ECE/TRANS/WP.29/2006/48

PROPOSAL FOR 01 SERIES OF AMENDMENTS TO REGULATION No. 117

(Tyre rolling noise)

Submitted by the Working Party on Brakes and Running Gear (GRRF)

Example 1

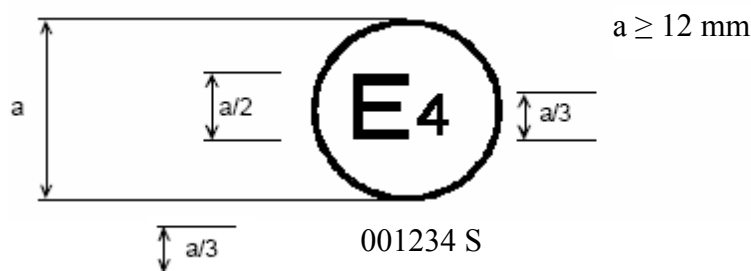
The above approval mark, affixed to a pneumatic tyre shows that a tyre concerned has been approved in the Netherlands (E4) pursuant to Regulation No. 117 (marked by S (rolling sound) only), under approval number 001234. The first two digits of the approval number (00) indicate that the approval was granted according to the requirements of this Regulation in its original form.

Example 2

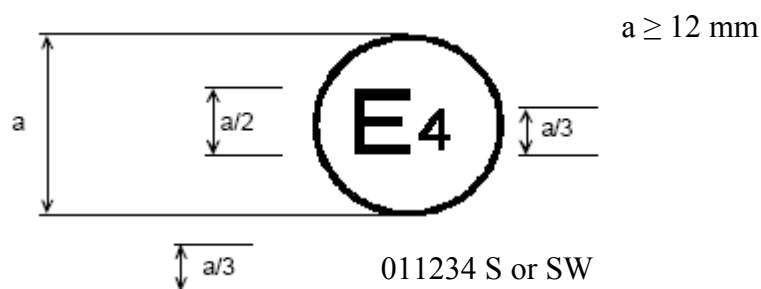
The above approval mark shows that the tyre concerned has been approved in the Netherlands (E4) pursuant to Regulation No. 117 (marked by S (rolling sound) or both S (rolling sound) and W (wet adhesion), under approval number 011234. This indicates that the approval is for S or both SW. The first two digits of the approval number (01) indicate that the approval was granted according to the 01 series of amendments.

Example 1

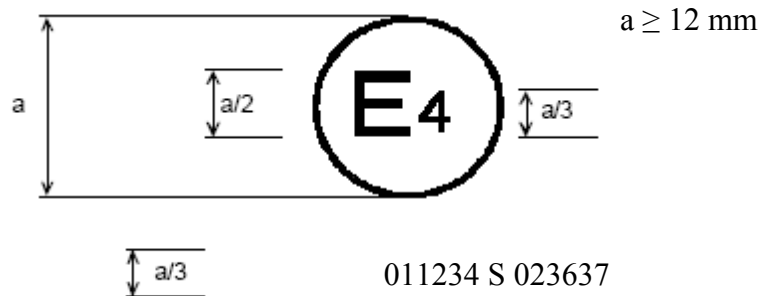
The above approval mark shows that the tyre concerned has been approved in the Netherlands (E4) pursuant to Regulation No. 117 (marked by S (rolling sound)), under approval number 011234 and Regulation No. 30, under approval number 023637. The first two digits of the approval number (01) indicate that the approval was granted according to the 01 series of amendments, but Regulation No. 30 included the 02 series of amendments.

Example 2

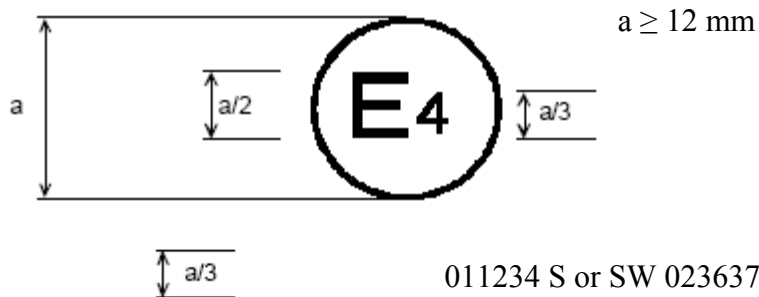
The above approval mark shows that the tyre concerned has been approved in the Netherlands (E4 pursuant to Regulation No. 117 (marked by S (rolling sound) or SW (rolling sound and wet adhesion)), under approval number 011234 and Regulation No. 30 under approval number 023637. The first two digits of the approval number (01) indicate that the approval was granted according to the 01 series of amendments, but Regulation No. 30 included the 02 series of amendments.

Example 3

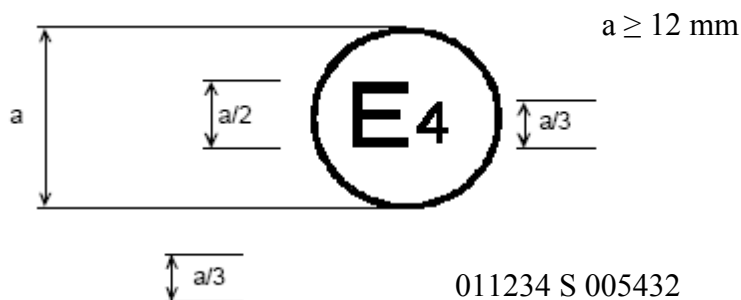
The above approval mark shows that the tyre concerned has been approved in the Netherlands (E4 pursuant to Regulation No. 117 and the 01 series of amendments under approval number 011234 (marked by S only), and Regulation No. 54. This indicates that the approval is for rolling sound (S) only, as Regulation No. 54 approved tyres at present cannot be approved for wet adhesion. The first two digits of the Regulation No. 117 approval number (01) in conjunction with 'S' indicate that the first approval was granted in accordance with Regulation No. 117 which included the 01 series of amendments. The first two digits of Regulation No. 54 (00) indicates that this Regulation was in its original form.

Annex - Appendix 2Extensions to combine approvals issued in accordance with Regulations Nos. 117, 30 or 54 2/Example 1

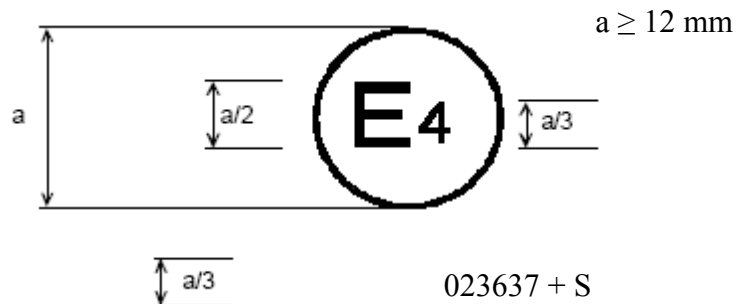
The above approval mark shows that the tyre concerned has been initially approved in the Netherlands (E4) pursuant to Regulation No. 30 and the 02 series of amendments under approval number 023637. It is also marked by + S (rolling sound) which indicates that its approval is extended under Regulation No. 117. The first two digits of the approval number (02) indicate that the approval was granted according to Regulation No. 30 which included the 02 series of amendments. The addition (+) sign indicates that the first approval was granted in accordance with Regulation No. 30 and has been extended to include Regulation No. 117 approval(s).

Example 2

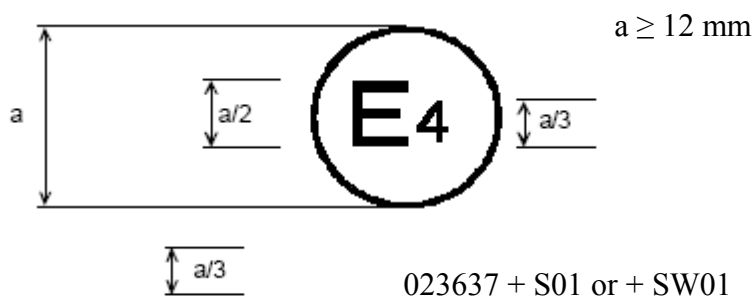
The above approval mark shows that the tyre concerned has been initially approved in the Netherlands (E4) pursuant to Regulation No. 30 and the 02 series of amendments under approval number 023637. This indicates that the approval is for S (rolling sound) or S (rolling sound) and W (wet adhesion). The S or SW followed by (01) indicates that it has had its approval extended under Regulation No. 117 which included the 01 series of amendments. The first two digits of the approval number (02) indicate that the approval was granted according to Regulation No. 30 which included the 02 series of amendments. The addition (+) sign indicates that the first approval was granted in accordance with Regulation No. 30 and has been extended to include Regulation No. 117 approval(s)."
